STATE OF NORTH CAROLINA  
DEPARTMENT OF TRANSPORTATION

WBS No: 46439.3.1  
TIP No: B-5935  
County: Anson  
Description: Remove and Replace Bridge #201 over Big Branch Creek on SR 1600 (Rocky Mount Church Rd.)

**Addendum No. 1**  
**October 21, 2015 Letting**

SHEET NO. W-1

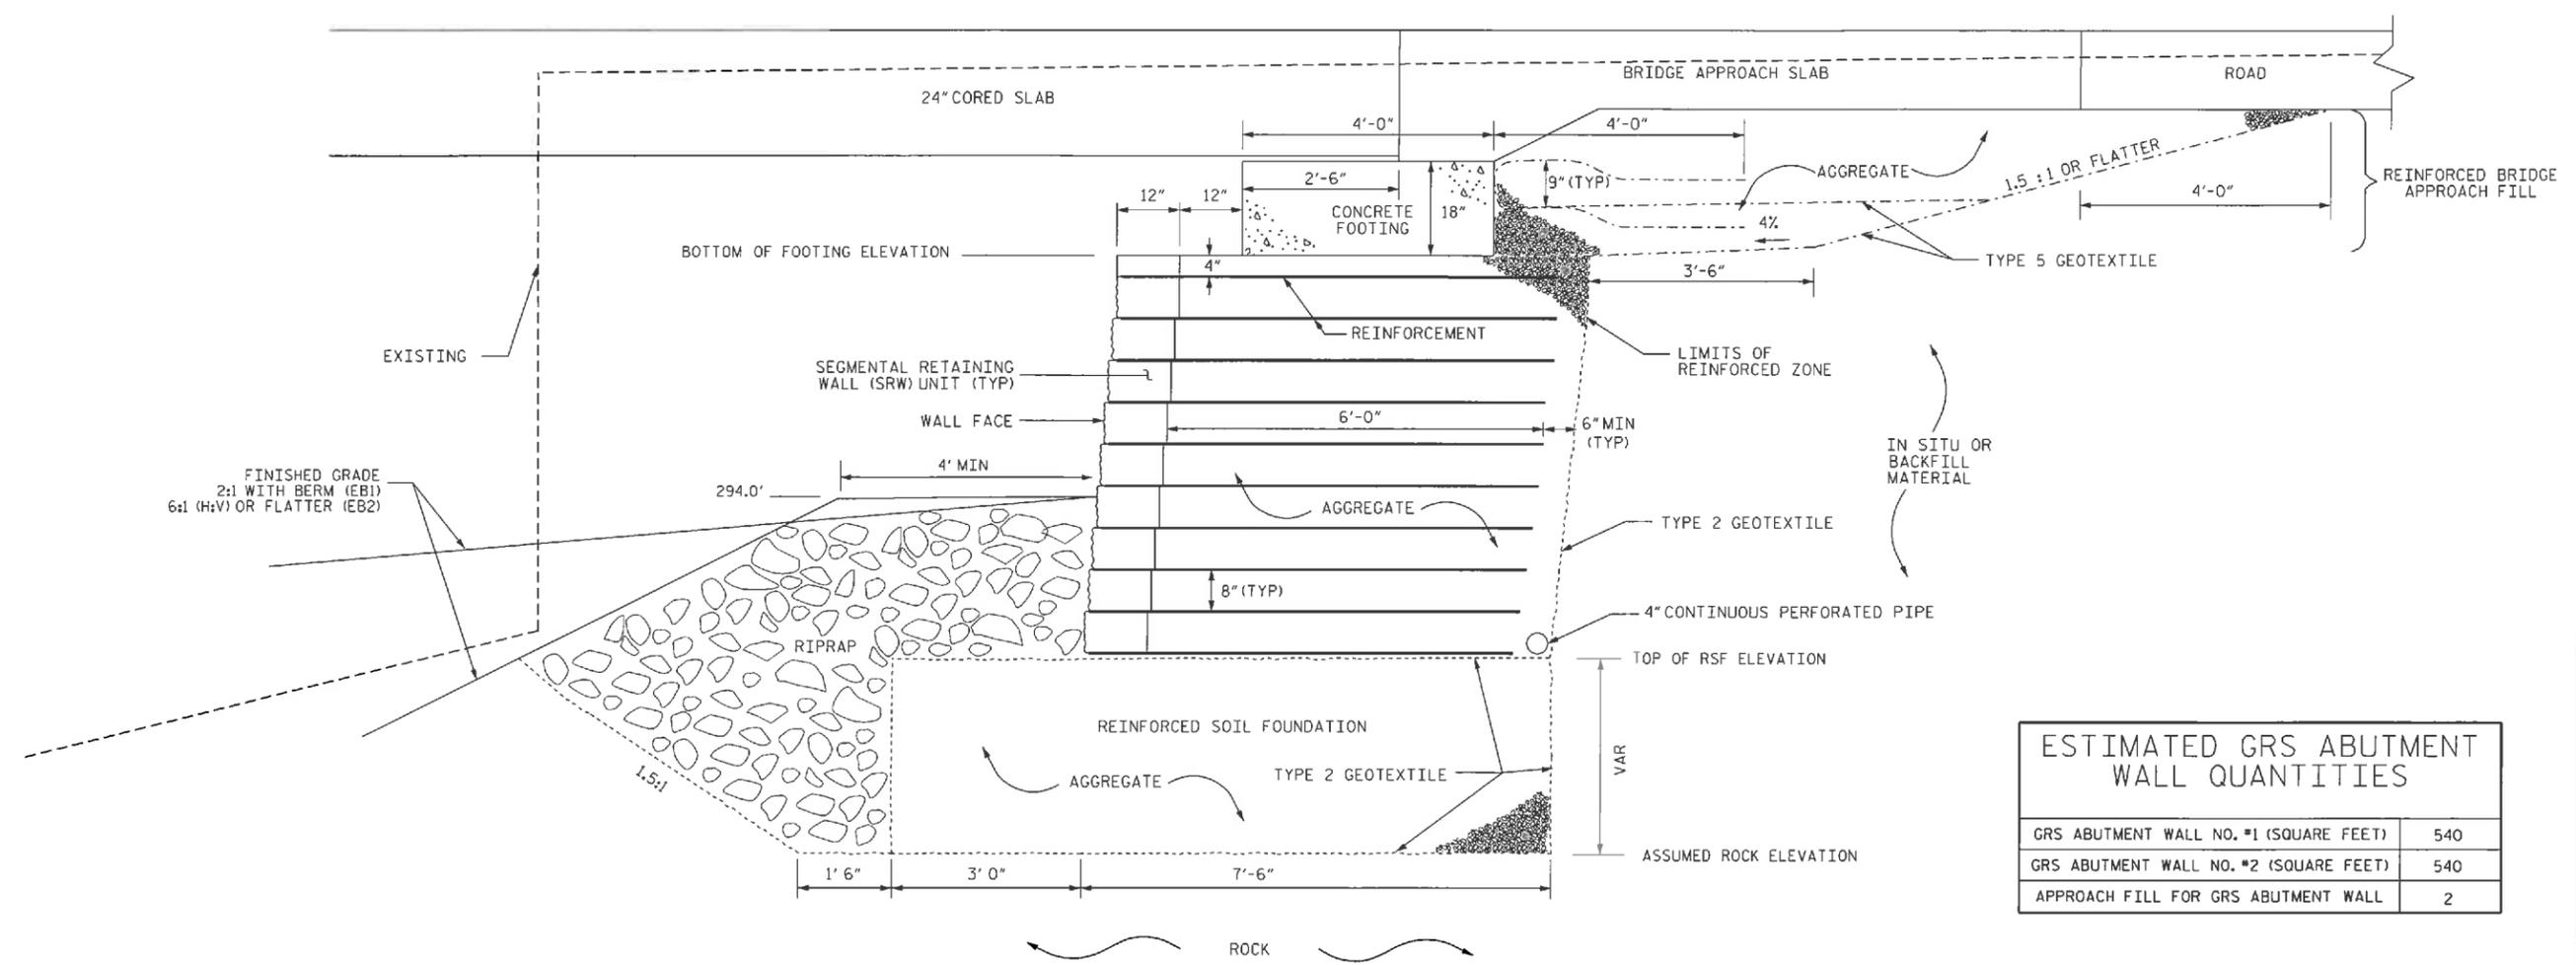
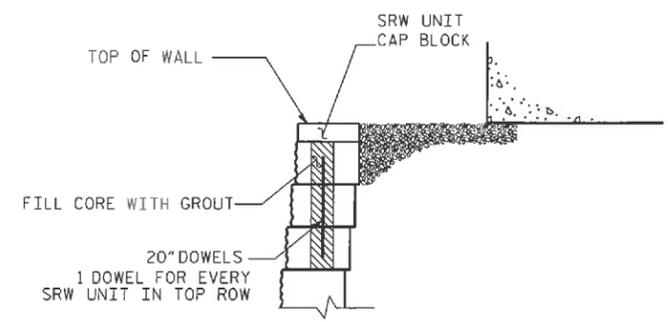
- The bid sheet will be revised to include line items for *Impervious Dike* and *36" Temporary Pipe*.
- A provision will be added to revise the special provision for Geosynthetic Reinforced Soil Walls. This revision will make the cost of the backfill material behind the reinforced zone incidental to the other pay items in the contract.
- A provision will be added instructing the contractor to salvage the I-beams from the existing structure.
- Plan sheet W-1, of the structure plans, will be revised to limit the surcharge loading on the reinforcement of the GRS wall to 250 lbs./sf

- FOR GEOSYNTHETIC REINFORCED SOIL (GRS) RETAINING WALLS, SEE GEOSYNTHETIC REINFORCED SOIL WALLS PROVISION.
- DO NOT PLACE REINFORCED SOIL FOUNDATION UNTIL EXCAVATION DIMENSIONS AND FOUNDATION MATERIAL ARE APPROVED.
- "TEMPORARY SHORING" MAY BE REQUIRED IN ACCORDANCE WITH THE TEMPORARY SHORING PROVISION. SEE ROADWAY, STRUCTURE OR TRAFFIC CONTROL PLANS.
- USE STRATA SG 700, SYNTEN SF 110, OR MIRAGRID 10XT FOR GEOGRID REINFORCEMENT. USE 100% COVERAGE.
- SURCHARGE LOADS ON THE REINFORCEMENT MUST BE LIMITED TO 250 PSF.
